NOTES FROM BRANDONPASS (w/ corrections)

Brandonpass's BL Notes
(http://www.areforum.org/forums/showthread.php?t=166659&highlight=brandonpass)
corrections in blue

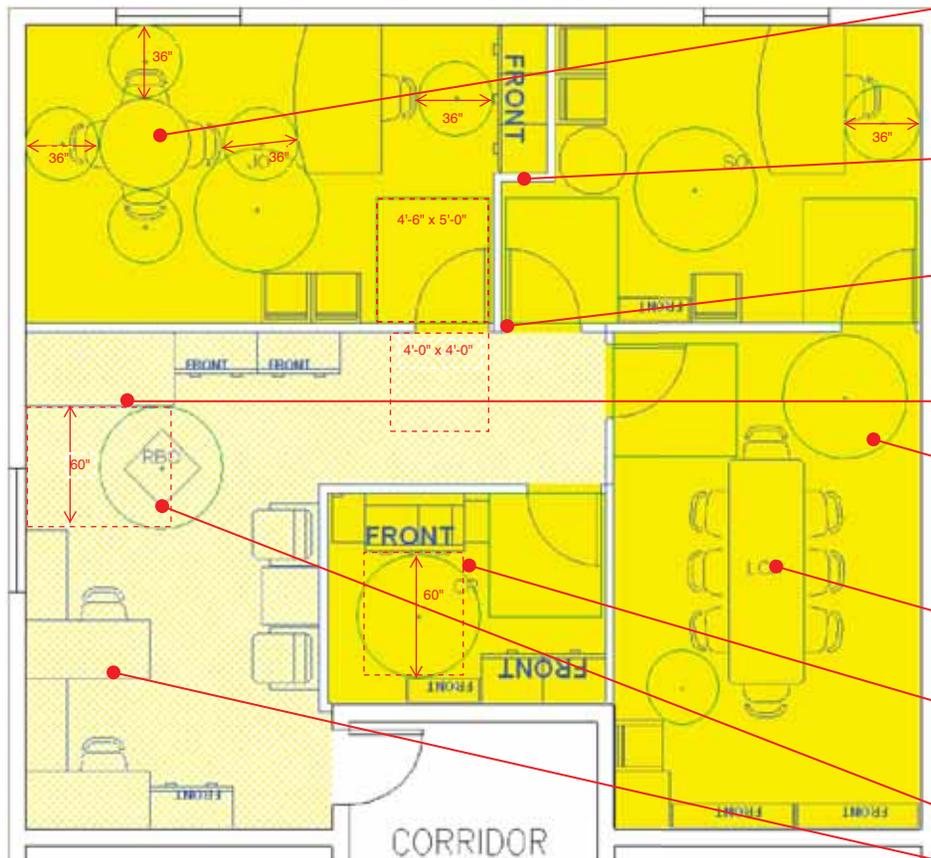
36: clear path: 36'' clear between wall and 44'' table. 36'' clear between two furniture elements. N chair has clear access due to 36'' provided between edge of chair and desk. W chair has access via southern route and 36'' clear between table chair and arm chair. W edge of table can be 36'' to wall since passage around chair is not necessary.

Doors: place one snap off wall. This will avoid bone headed placement of goods behind the door. Just remove the possibility from even happening. Don't be stupid.
Pull: 4'-6'' × 5'-0''
Push: 4'-0'' × 4'-0''

Work Table: 60'' clear space at front of the work table. (Ballast p.31)

Clear floor space: since the swing direction of the 2nd door from Smith's office does not matter, place it in his office. Bastard has too much space anyway. This will avoid the overlap of the door swing/clear floor space and the 60''dia turn radius. Although some codes vary on the issue, this will nullify the discrepancy by separating the two.

Conference Room: Maintain 36'' clear behind all chairs. However end chairs, one may have a 36'' clear between wall and table edge as long as all chairs are accessible via 36'' clear path.

Copier room: Placement of the copier allows for the 60'' clear in front of copier (Ballast p.31) while preserving the clear floor space for the door and swing. Although some codes vary on the issue, this will nullify the discrepancy by separating the two.

Secretary desk layout: Most efficient & compact layout for the secretarial desks. It is narrower and shorter in length. This example allows direct access to the desk seating from a common circulation space whereas the second example (below) creates a separate 'aisle' which consumes more space. This example also provides for the 60'' in front of the work table.

WRONG: inadequate clearance to SW corner chair. There must be 36'' clear between the SE char and the wall to gain access to the SW chair.....OR the same can be done for the NW chair to gain access to the SW chair although this would push the NE chair too close to the desk. As a result you would have to move the desk, credenza wall partition, SO seating and desk. there is room behind the SO desk so this would probably work although time consuming.

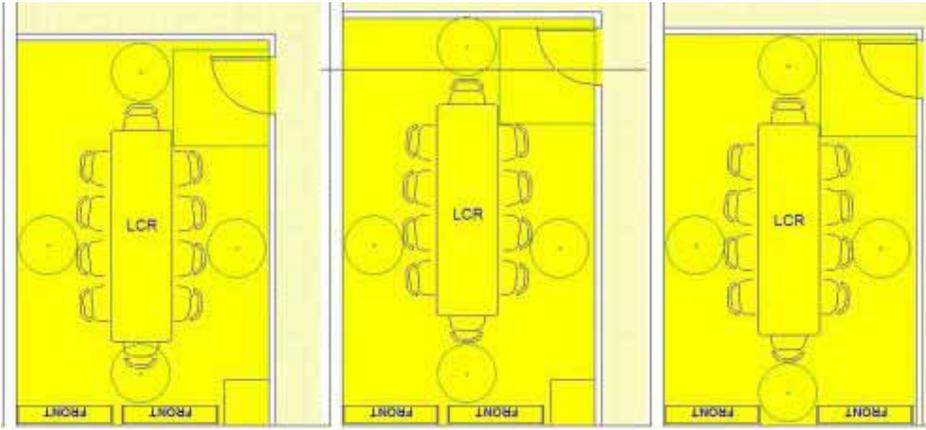
NOTE: I'm finding the 45deg rotation of the table to be super problematic. seems like it makes more space but it makes clearances a bit confused.

PUSHING IT: discrepancies exist between study materials and forum dwellers on this issue. 36'' vs 60'' at front of work table. This particular example is a result of an inefficient secretary desk layout.]]

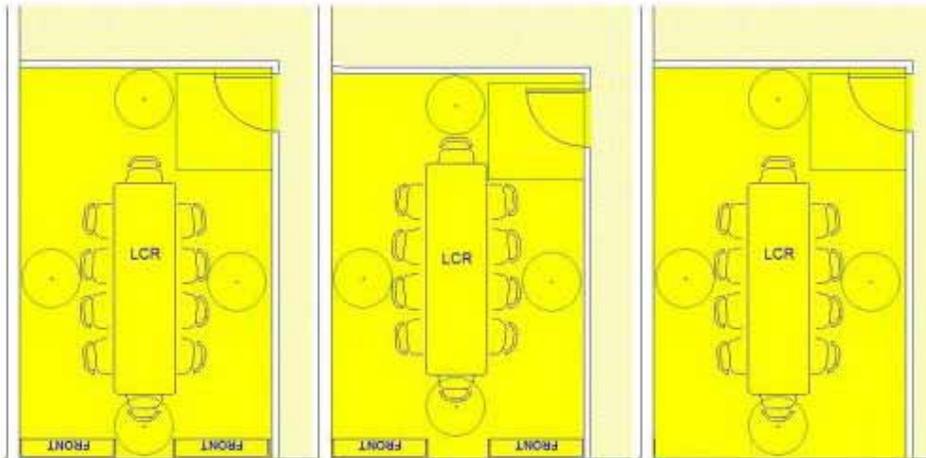
Secretary Desk: this layout although acceptable, takes up way too much space compared to the above example. A separate space is created, the width and length are substantially larger and as a result, create a tight path relative to the lounge seating and does not allow for 60'' in front of the work table. Also, look at that stray file cabinet? What a dog! Again, it works but damn that's shitty design.

'L' Shaped Room: A nice trick to recess the bookshelves. Be aware of the door clearance space. Such a move could result in a serious time consuming trickle effect if you don't know what the hell your doing. I.E.: *place shelved, move door up, move 'SO' office wall up, have to move arm chairs, 'SO' door clearance is compromised, move West wall, pinch 'JO' office etc, etc.. Next thing you know, there's five minutes left and you completely botched a passing solution for the sake of built-ins.* Moral of the story...do it early or not at all and practice it. Sweet move when you know where it has to be.

PUSHING IT: Although acceptable, the arm chair relative to the end conference table seat does not allow for 36'' passage. 36'' clear does exist between the arm and the table edge and the seat is accessible from a clear path via the East of the table but still.... not very smart or efficient.

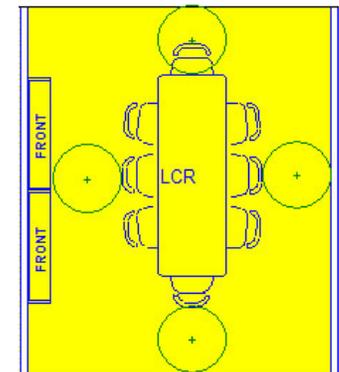
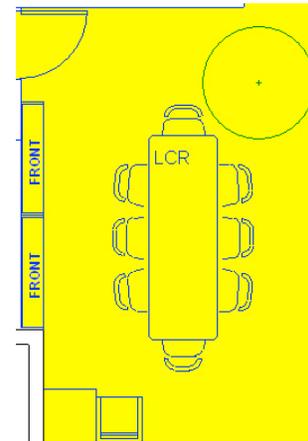
1: **Wrong** because there is not a clear 36" path between two furniture elements. If there were no bookshelves in this scenario (edge of shelves were where wall would be) then it would be acceptable. See example below

2: **Correct** because clear 36" path all around.

3: **Correct** because there is a clear 36" path around table and directly to the Southern most chair. See flow diagram on next page.

4: **Wrong** because there is not a continuous 36" path to the Southern most chair.

5. **Correct** because there is a clear 36" path around table and directly to the Southern most chair. See flow diagram on next page.

6: **Correct** because there is a clear 36" path around table and directly to the Southern most chair. See flow diagram on next page.

LEFT: Acceptable since there is a clear path around the table of 36" and the southern table is accessible via 36" path unobstructed. See flow diagram next page

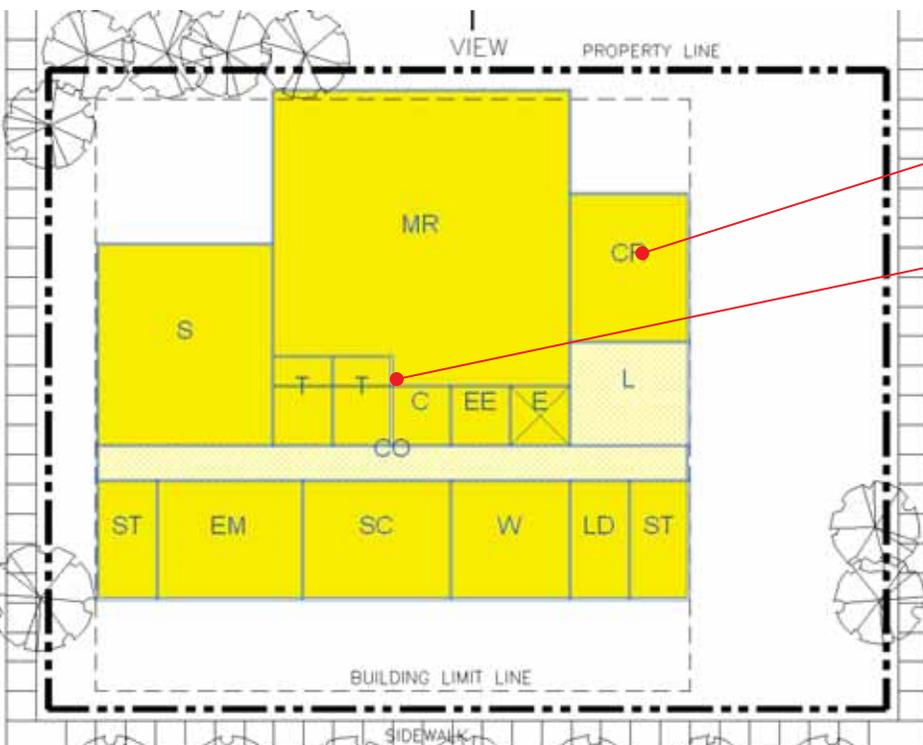
Step 1: Layout spaces based on prescribed pro-grammatic areas using logical dimensions that will be common to similar size spaces. These similar dimensions will tie these spaces together as a whole for a particular 'wing, area or bar. As a result, when you get to step 5 & 6 you may find that everything aligns nicely and fits within border. Use your head. Don't be stupid. If its 2,500sf then you know its 50' x 50' so draw it that way....at least for starters. Coming up with nifty proportions will only create a visual predisposition to orientation that may ultimately lead you a stray. Be square and be there. I start with the spaces with the obvious sizes such as the 10' x 20' dimension of the stairs (ST), the obvious 10' x 15' for the toilets (T) and the obvious 10' x 10' for the elevator shaft (E), elevator machine room (EE) and custodian (C). After I drew these first, I laid out the other spaces to match the appropriate dimension. For instance; using the long side of the stair (ST) of 20', I used this as the short side of the mechanical (EM), special collections (SC), workspace (W) and the lending desk (LD).

Step 2: Group small "dark" utilitarian functions that you know will be nested at the double height space. Based on the smaller square footages, you can see a commonality. Group them based on their puny size.

Step 3: Layout what you know based on pro-grammatic directive and code restrictions.
- Lobby (L) is to be at the East therefore place it at the East property line.
- Main Reading (MR) and Children Reading (CR) are to have 'views' which the program AND the plan indicate is to the North therefore place these spaces at the north property line
- Stacks (S) are to be adjacent to the MR therefore you know it needs to be with the North spaces. Place it at the North property line

Step 4: Nest those 'dark' utilitarian spaces. Move them functions just below the North spaces as you planed (or I do at least) nest them in the big box spaces. (Dorf master strategy!!! it works!!!)

Step 5: Move all the remaining medium size spaces, to the bottom. The corridor becomes obvious.

Step 7: Before you start panicking and fucking with every spaces dimension that you so carefully laid out to the inch, adjust all the spaces into a coherent assemblage that will resemble your final layout. Again, don't mess with the dimensions yet. See what happens when you lay them out.

Step 8: The only adjustment I needed to do to get everything to fit within the building setback lines was rotate the children's reading (CR). My assumption of dimensions...all based on the obvious seemed to work out (at least this time)

Step 9: Gut check....as it is, it works depending on how you feel about 'L' shaped spaces. However, I like the clean lines and felt I could get into a squeeze on the second level. So when you hit the next page you will see the adjustments made in the final solution.

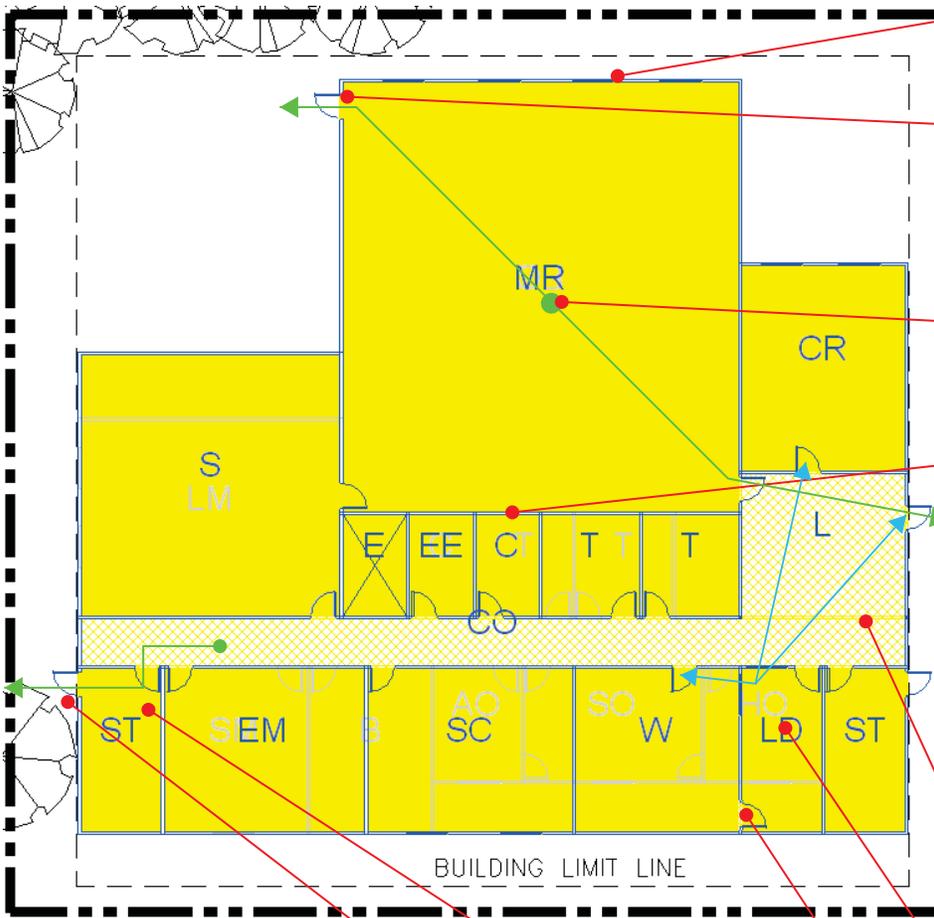
Windows: use sizes between 4'-0'' to 10'-0'' and make a judgement call on quantity for the space being served. No window is required at the 'Open to Below (OB) volume at the second level.

Egress: Be careful to swing all doors in the direction of travel that are to be used as exits.

There is **no square footage trigger** to add an additional egress door for larger spaces. It will be dictated in the program requirements or inherent to particular spaces. I.E. Lobby/entry (L) and stairs (ST). Double doors only if required by program. We have not been asked to calculate egress factors.

Two means of exiting the larger space, be sure that the exit doors are **no closer than 1/2 of the diagonal distance of that space**. In other words, if you have them at opposite corners as shown here you are twice the minimum and thus, golden.

Nesting: Similar type functions of smaller size work well together. When compared to the previous page 'process', I have elongated all the spaces in the N-S direction. This is because when I rotated the toilet spaces to match the 10' dimension of the elevator and custodian spaces, it extended beyond the West edge of the Main Reading (MR). I didn't like the prospect of an 'L' shaped stack (S) room nor the effects it may have on the second level. Therefore I decided to tweak every space to be congruent with that nice square(ish) reading room and result in an nice square(ish) stack space. Also, I flipped the Elevator to the West as well. Since this is only a two story space and the elevator is not a primary means of circulation but rather an accessibility concern, I relocated it to the corridor for similar 'L' concerns and also when the elevator machine room is removed from that ban of spaces on the second level, there was nothing that could fill the void. It all could still work, but I like to keep my toilet locations relative to each other although not a concern on the exam. Just makes sense. See the next page example to see all this crap in action.

Wall openings: NOT for visual control or direct access. It is only to delete the common wall between lobby & corridor or corridor & corridor. It is meant to adjoin circulation spaces.

Visual Control: Achieved only with windows...even at the interior partitions. The 'visual control' is to watch door access to the space required in the program. NOT just a view of that box. It may provide control of either side of the door operation as shown between the work space and the lending desk. Here, the LD is watching the door from the W's inside.

Exiting: No door is required at the end of the corridor. Existing is allowed THRU the stairwell from the corridor from the ground level. However, be sure not to pull a Sunny Bono on that tree there. Could probably move the whole building North a bit to take care of this. Also be careful of the **dead-end corridor**. 20'-0'' max.

Near: If a door is programed to be 'near' another space, make sure it is within 1/2 that floors length. NOT 5' - 10' as proposed within the forum, nor 20% as with Site Planning.

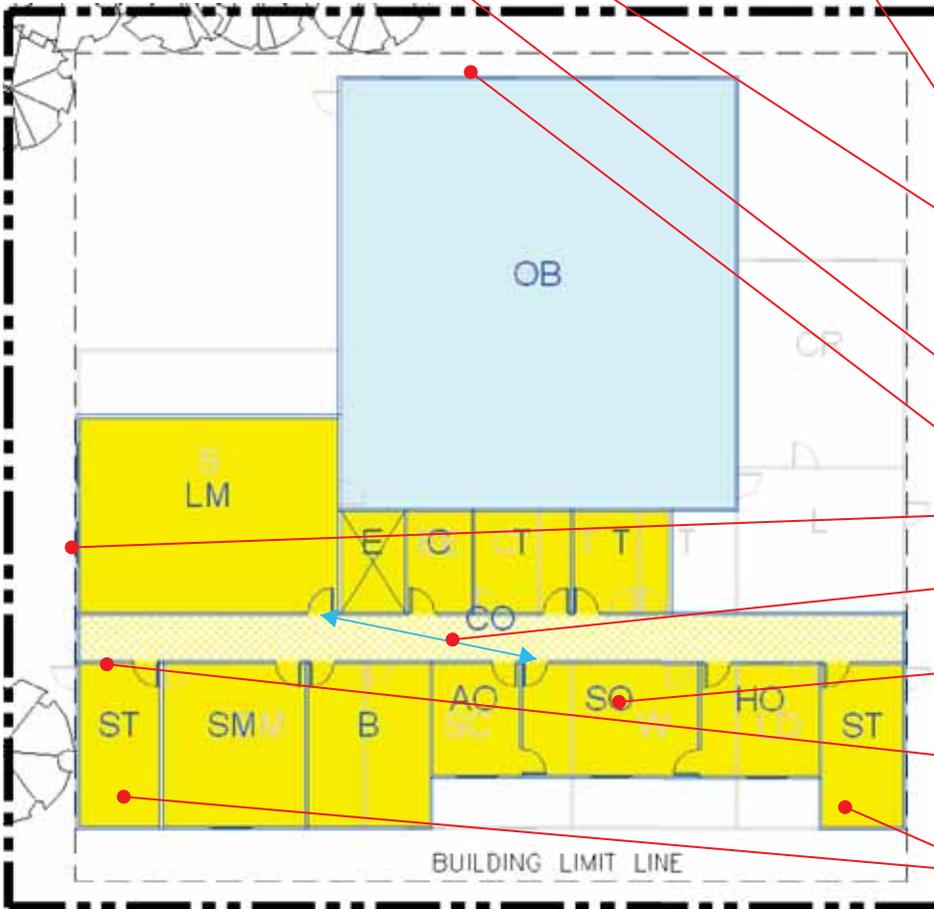
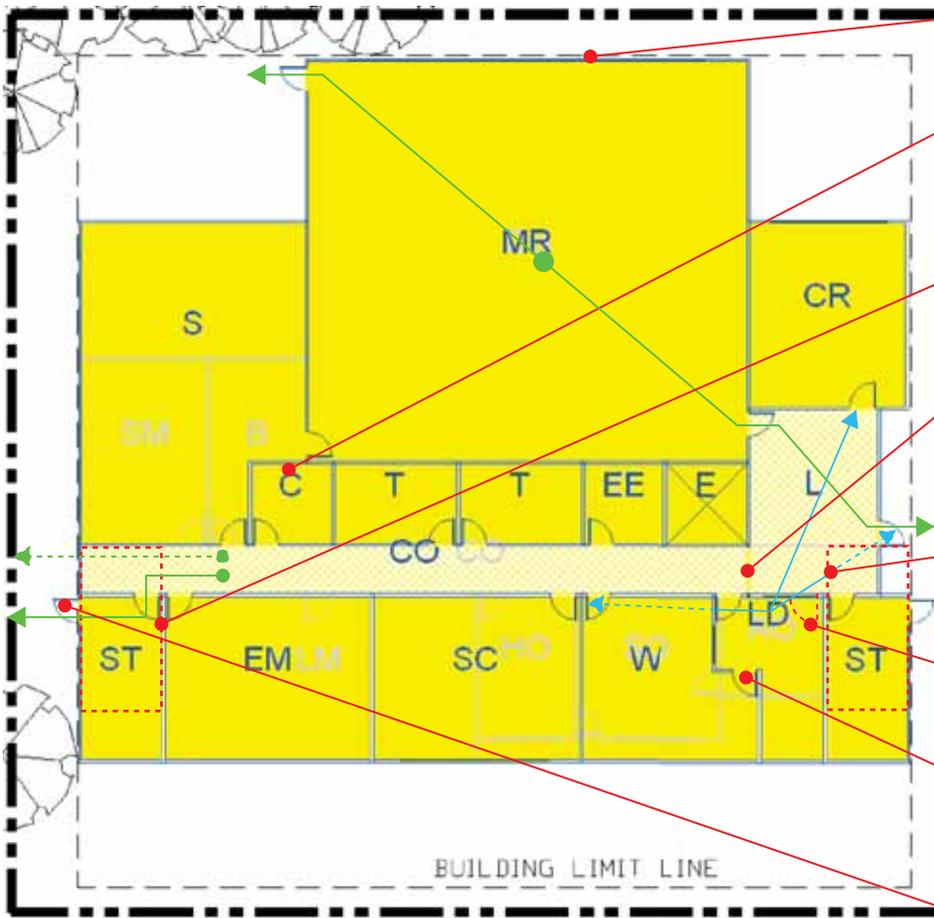
Windows: One gigantic window as shown here may not cut it. Computer grading may only take into account one window as opposed to linear feet of window.

As a result of the comments on the previous sheet, you can see what happens if you just leave the spaces per your perfect 'obvious' dimensions. Some tweaking may be in order to make this baby sing. As is, you get a nasty 'L' shaped stack room (S) which may be acceptable since a larger space, but look at that break room (B) on the second level. Not good.

Stair: As dashed, the stair tower at this end could probably be moved to get rid of that nugget of unused corridor. Remember, exiting can be thru a stairwell. However, not advisable for the East stair for comments below.

In this example, the corridor stops at the lobby. The previous example shows the corridor extending the full length with the lobby (L) set above it. By doing this you gain a bit more length to the lobby for whatever purpose you may need....may make access to some other doors easier. And as far as both of these examples are concerned we are no where near the 25" of the total square footage cutoff point.

Visual Control: For view of doors, not boxes. As shown, the main entry door may be getting to an oblique angle and not as 'visible from the loan desk (LD). Also, if the stair is nudged North as suggested for the West stair, it may block views of the entry entirely.

Would be better to move LD door to East to gain better **'visual' angle** of the doors needing control. Also, if you refer to the previous example, by doing so, the door into LD does not block the window for 'visual' of the workspace door.

'L' shaped rooms at this small size is a BAD idea.

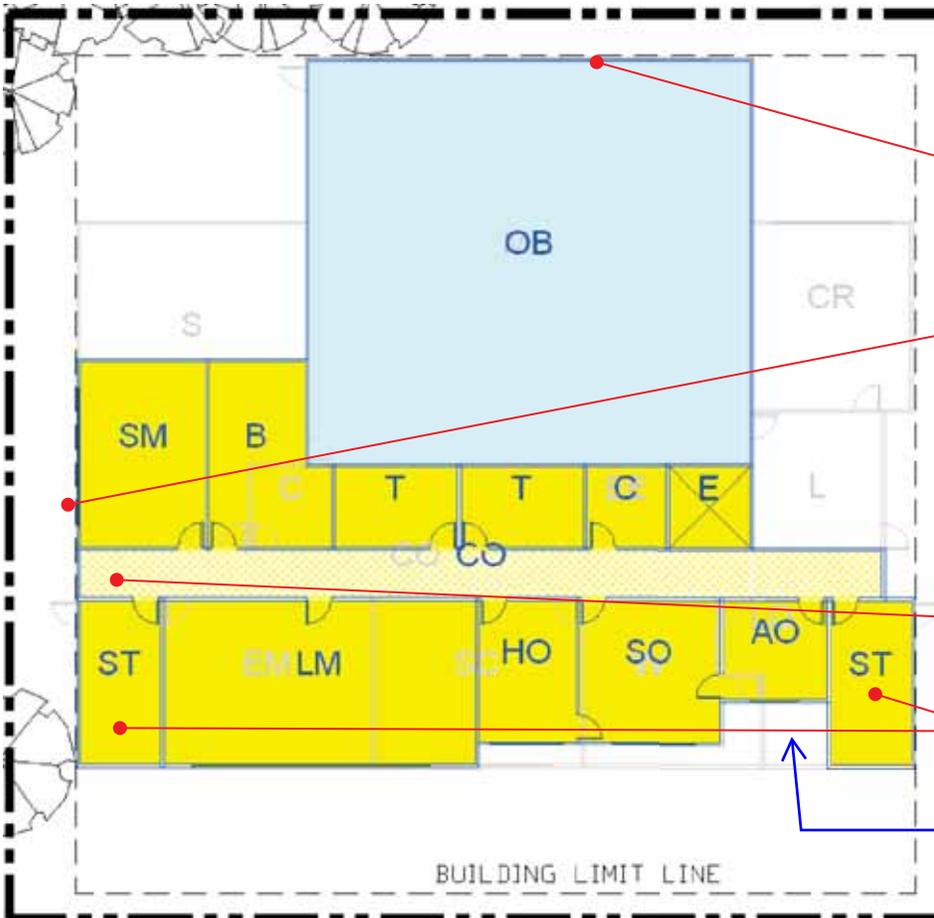
Near = on the "same half of the same floor"

Near: If a door is programed to be 'near' another space, make sure it is within 1/2 that floors length. NOT 5' - 10' as proposed within the forum, nor 20% as with Site Planning.

Dead end corridors: although not dead ends here, could probably tighten up a bit by pulling back to just outside the door at both ends of the 2nd floor corridor and the West end of the 1st floor corridor.

Keep exterior recesses (niches) w/in 2:1 ratio. This falls under the "sound design logic" category
